PORTH-25 Sector Plan

COUNCIL BILL NO. R-09-263

1
2 REPEAL OF THE 1986 NORTH I-25 SECTOR DEVELOPMENT PLAN AND
3 ADOPTION OF THE REVISED NORTH I-25 SECTOR DEVELOPMENT PLAN
4 AND ADDITION OF DESIGN STANDARDS AND AN SU-2 PREFIX FOR CERTAIN
5 PROPERTY'S WITHOUT A SECTOR PLAN DESIGNATION WITHIN THE
6 REVISED NORTH I-25 SECTOR BOUNDARY AS SPECIFIED IN EXHIBIT 1. THE
7 REVISED SECTOR PLAN BOUNDARIES ARE PASEO DEL NORTE AND SAN
8 BERNARDINO AVENUE TO THE SOUTH, LOUISIANA BOULEVARD TO THE
9 EAST, THE NORTH DIVERSION CHANNEL AND EDITH BOULEVARD TO THE
10 WEST AND SANDIA INDIAN RESERVATION'S SOVEREIGN LINE ON THE
11 NORTH AND CONTAINS APPROXIMATELY 2,800 ACRES.

2 AMENDING THE NORTH I-25 SECTOR DEVELOPMENT PLAN TO INCLUDE A
3 REVISED DEFINITION OF SU-2/MUD ZONING AND TO INCLUDE THE
4 CORONADO VILLAGE MOBILE HOME PARK SITE IN THE LAND USE DISTRICT
5 OVERLAY MAP AND TO AMEND THE SU-2/MUD ZONING DEVELOPMENT
6 STANDARDS.

Figure 10
LAND USE
DISTRICT
OVERLAY

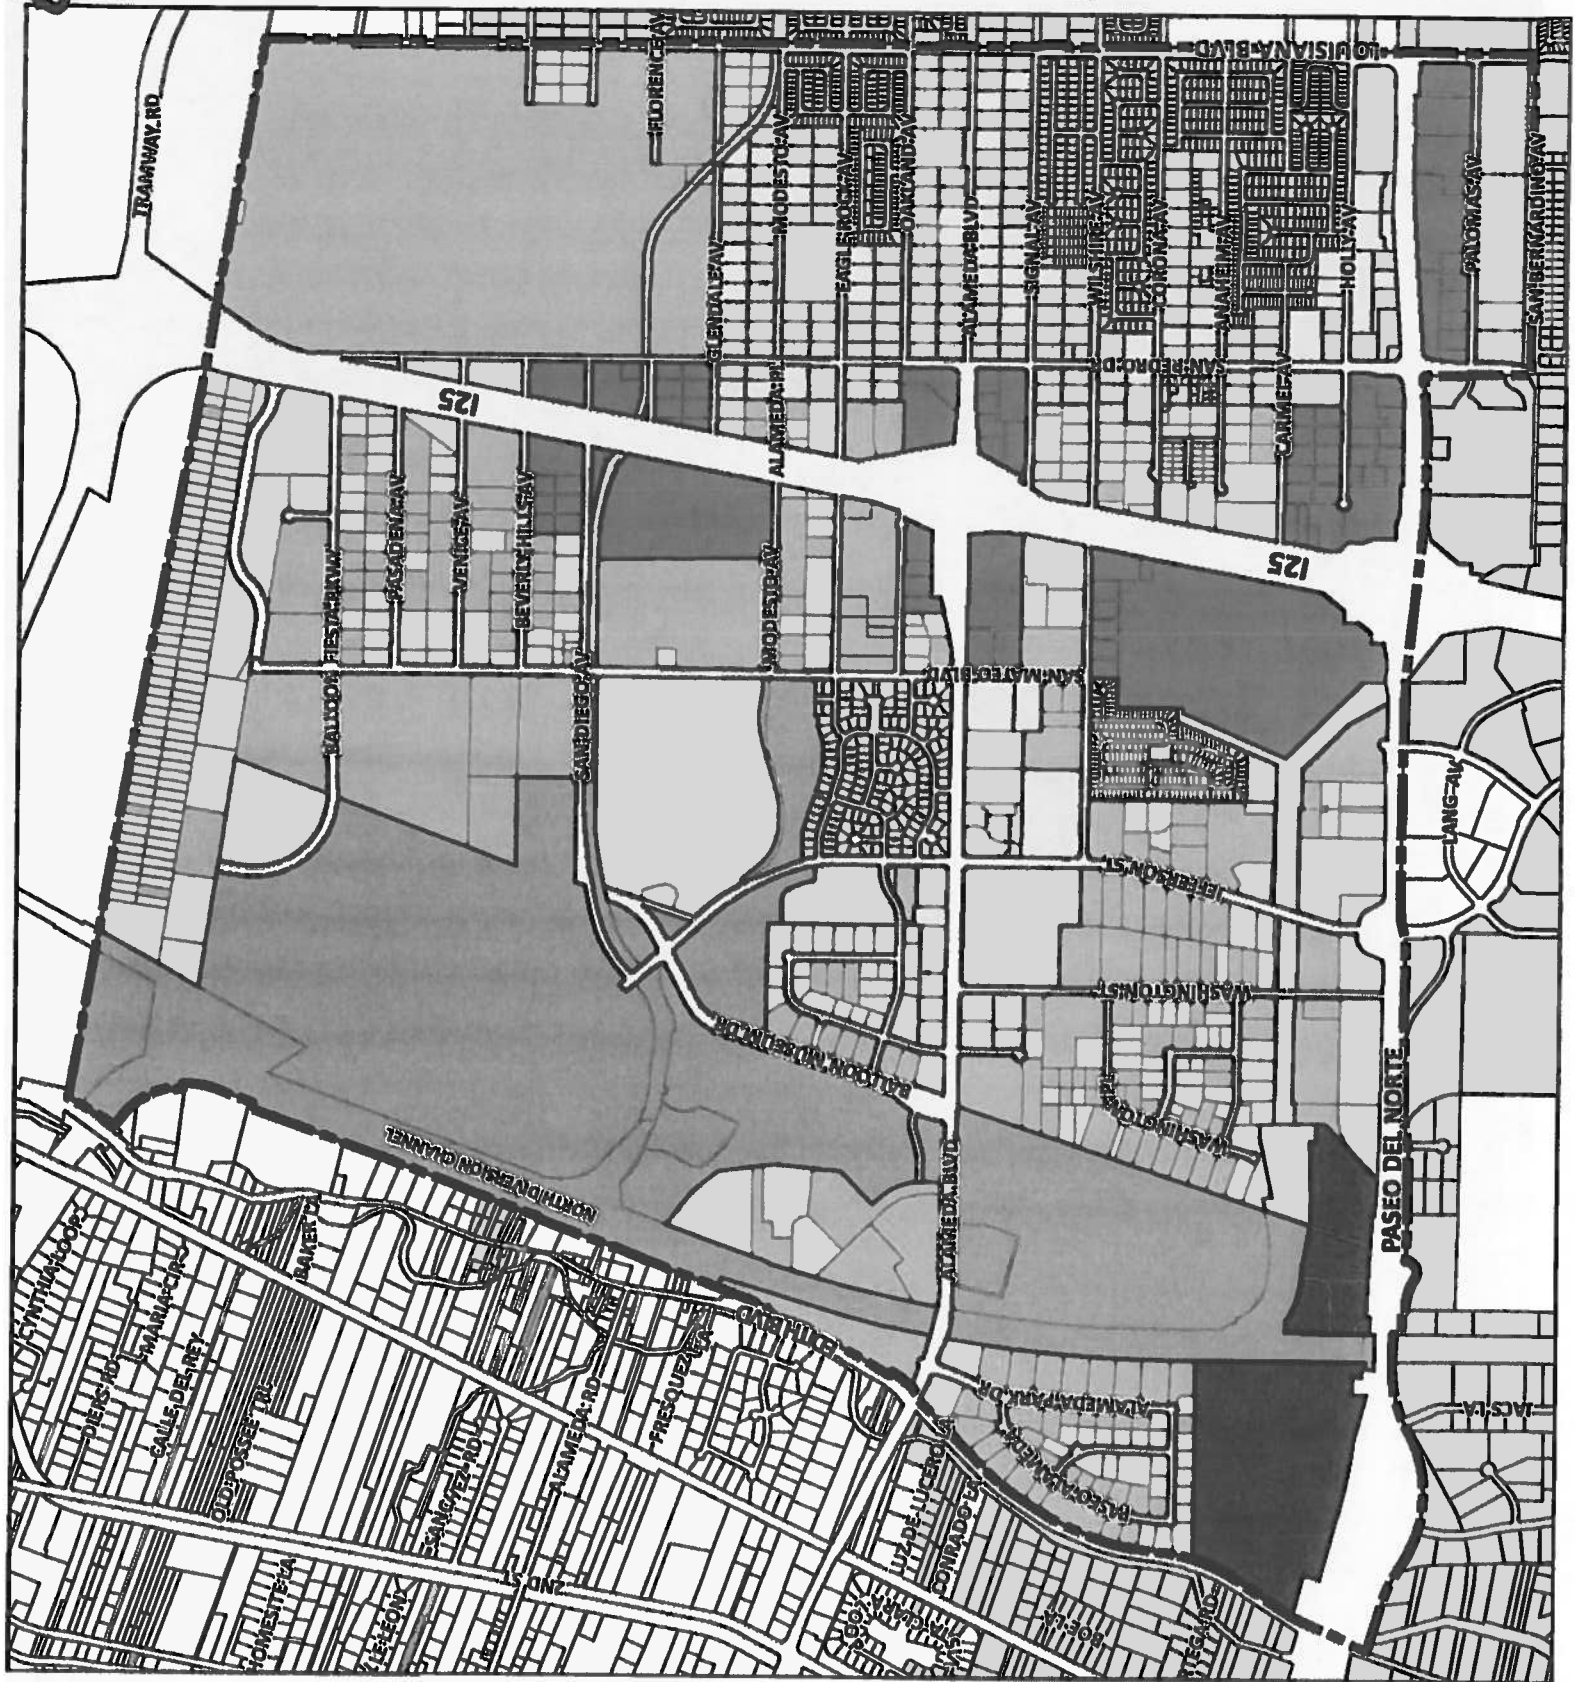
22 A. The title of Figure 10, the Map on page 25, "Proposed Land Use Plan"
23 shall be amended to read "Land Use District Overlay".

24 B. The parcel described as Tract A-1, plat of Tract A-1 Coronado Village,
25 containing approximately 57.3349 acres and located in the northwest
26 quadrant of the intersection of Interstate-25 and Paseo del Norte, is
27 included in the Land Use District Overlay presented in the Plan and is
28 designated an overlay district of RC (Regional Commercial).

29 C. A revised map showing this property within the RC overlay is attached
30 as Exhibit A. This map shall substitute the current Figure 10 on page 25
31 in the Plan document.
